Project Number: SP2018-002
Project Name: Interstate Wire Company
Project Type: SITE PLAN
Applicant Name: DB CONSTRUCTORS INC
Owner Name: ROCKWALL ECONOMIC DEVELOPMENT
Project Description:

SP2018-002 - SITE PLAN FOR INTERSTATE WIRE COMPANY
SITE PLAN - LOCATION MAP =

City of Rockwall Project Plan Review History

AGENDA ITEM: **SP2018-002**; Site Plan for *Interstate Wire Co., Inc.*

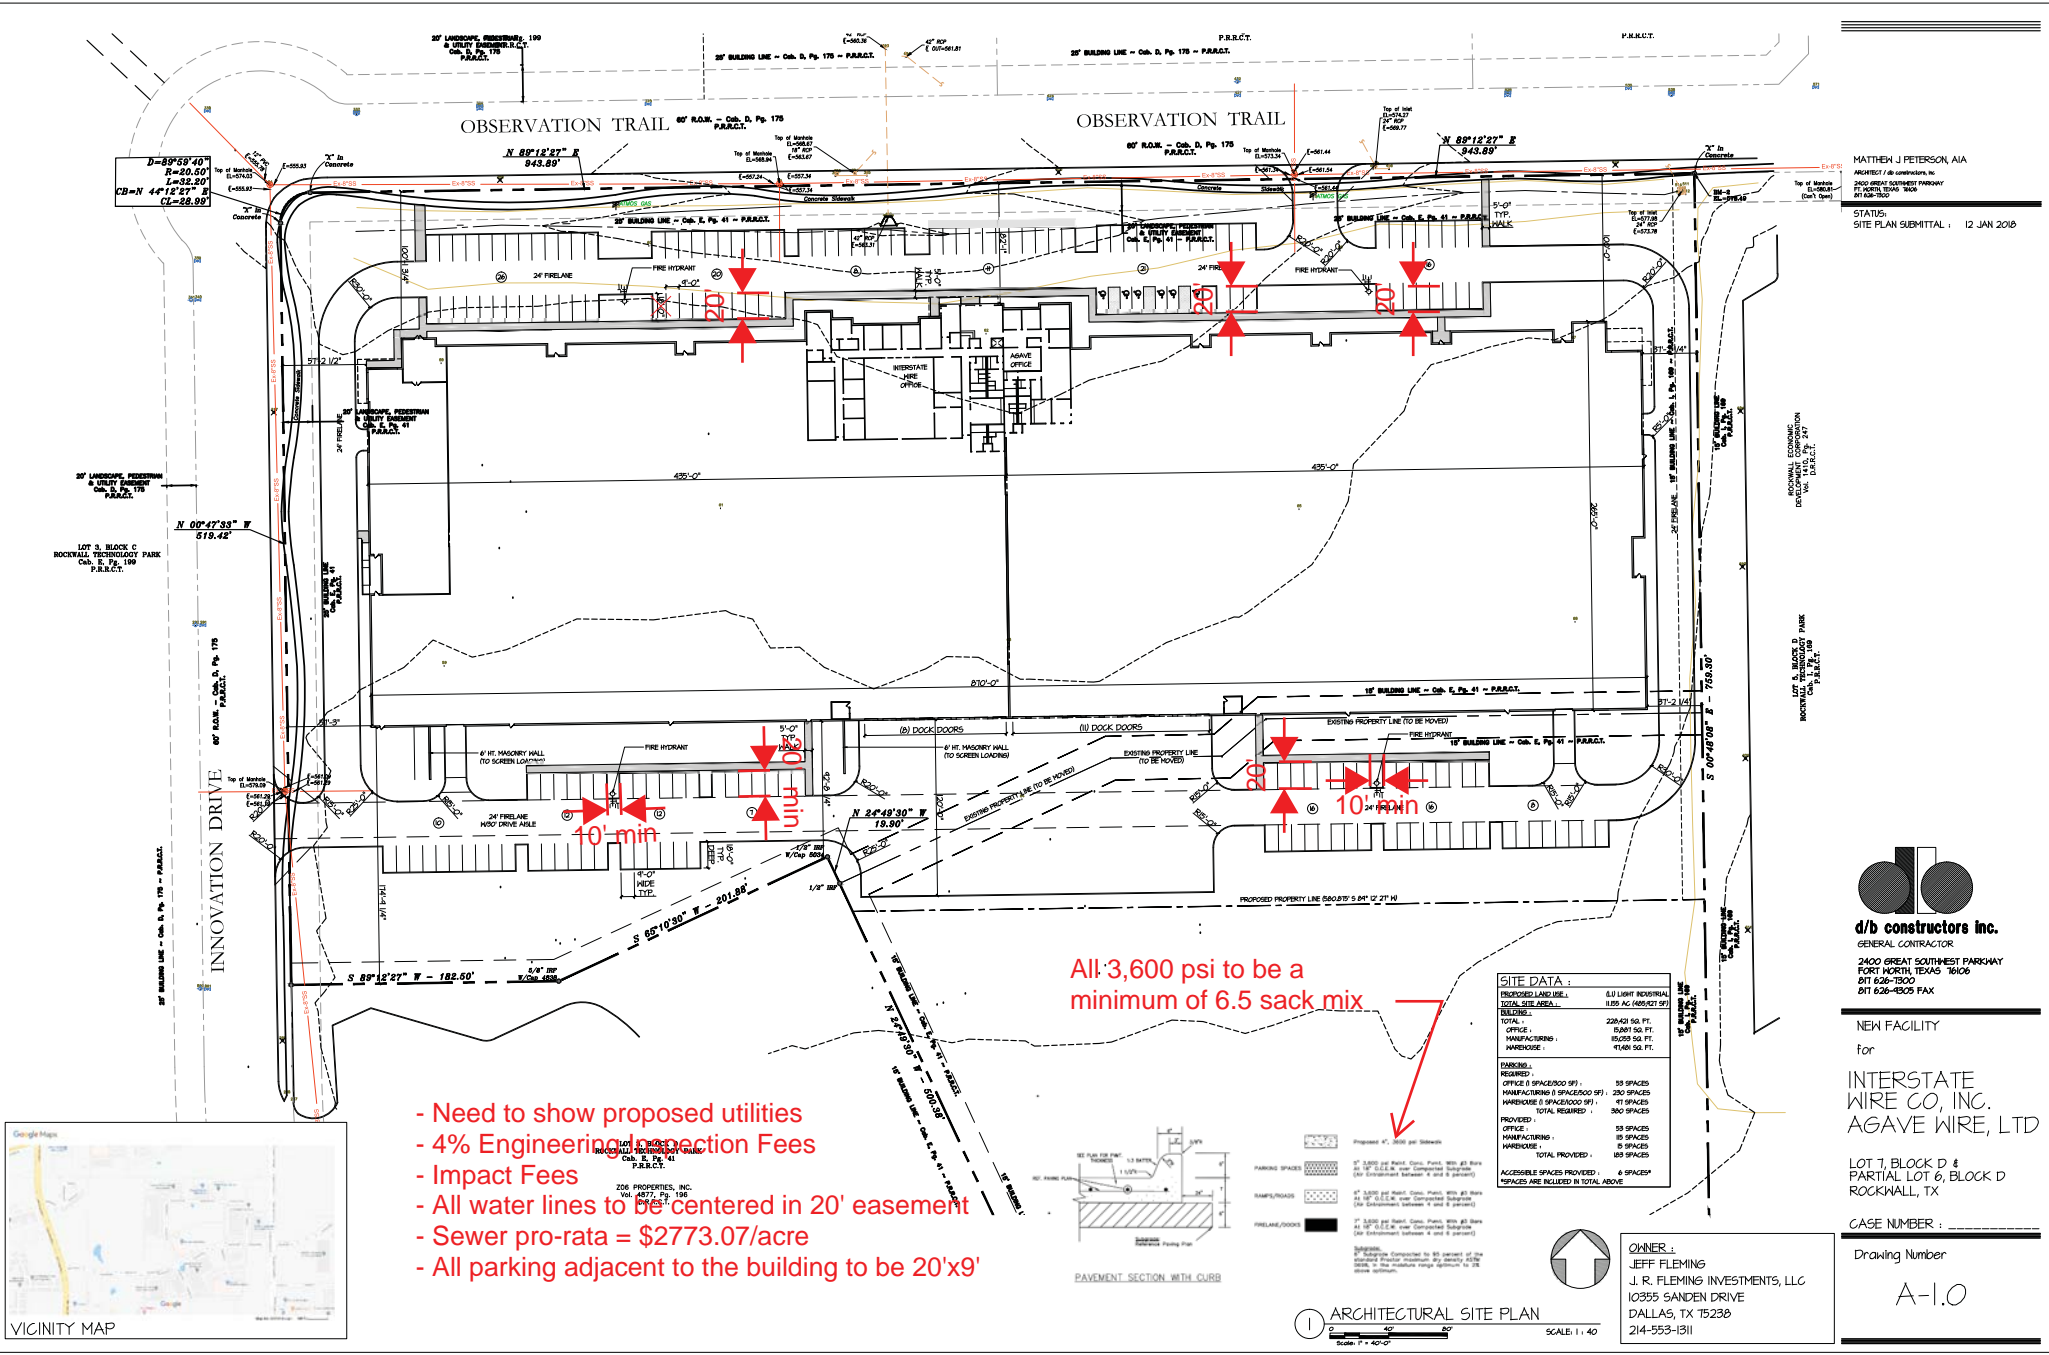
a. Where is the trash dumpster enclosure located? Will this exception be requested?

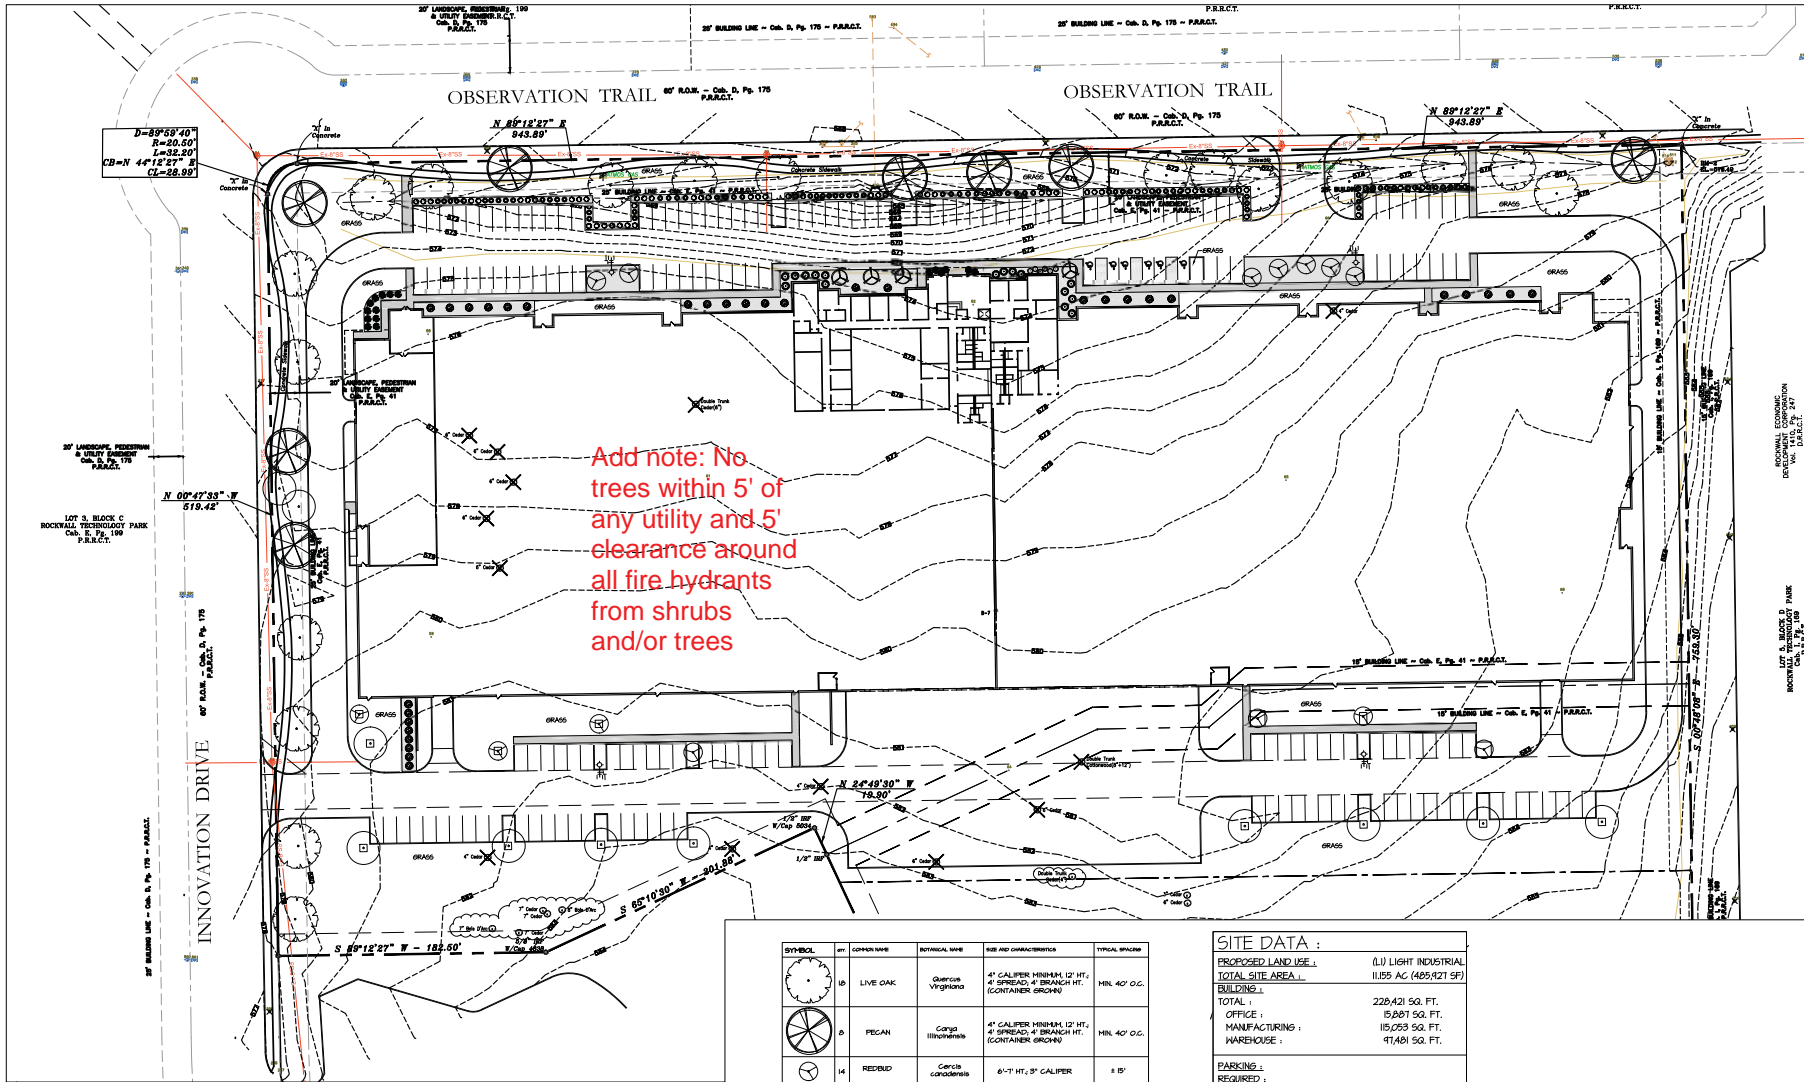
- Need to show proposed utilities
- 4% Engineering Inspection Fees
- Impact Fees
- All water lines to be centered in 20' easement
- Sewer pro-rata = \$2773.07/acre
- All parking adjacent to the building to be 20'x9'

All 3,600 psi to be a minimum of 6.5 sack mix

Add note: No trees within 5' of any utility and 5' clearance around all fire hydrants from shrubs and/or trees

Drawing Number
SL1

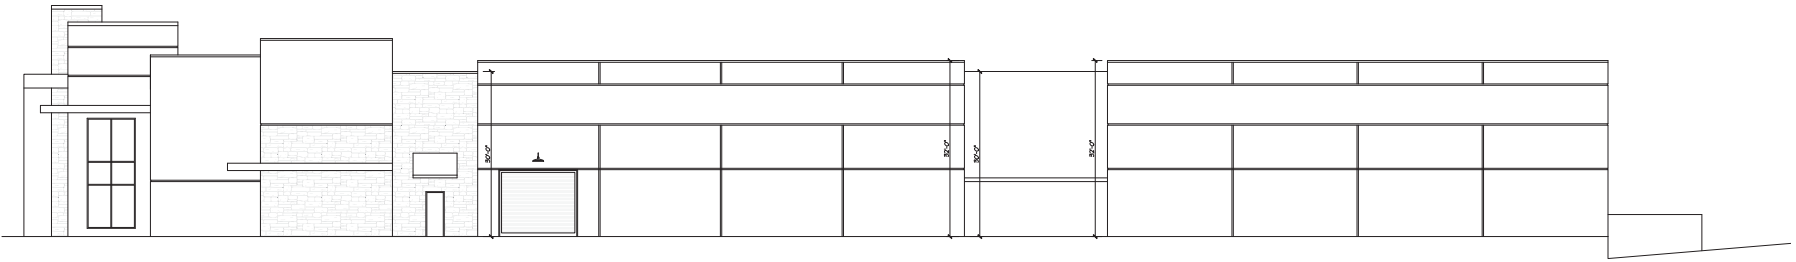
PROVIDE POLE DETAIL

Drawing Number
SL1

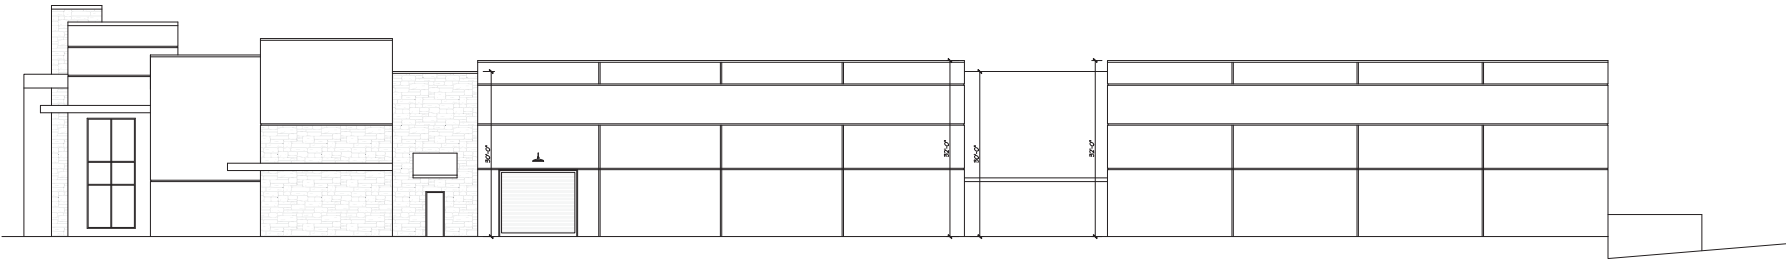
PROVIDE POLE DETAIL
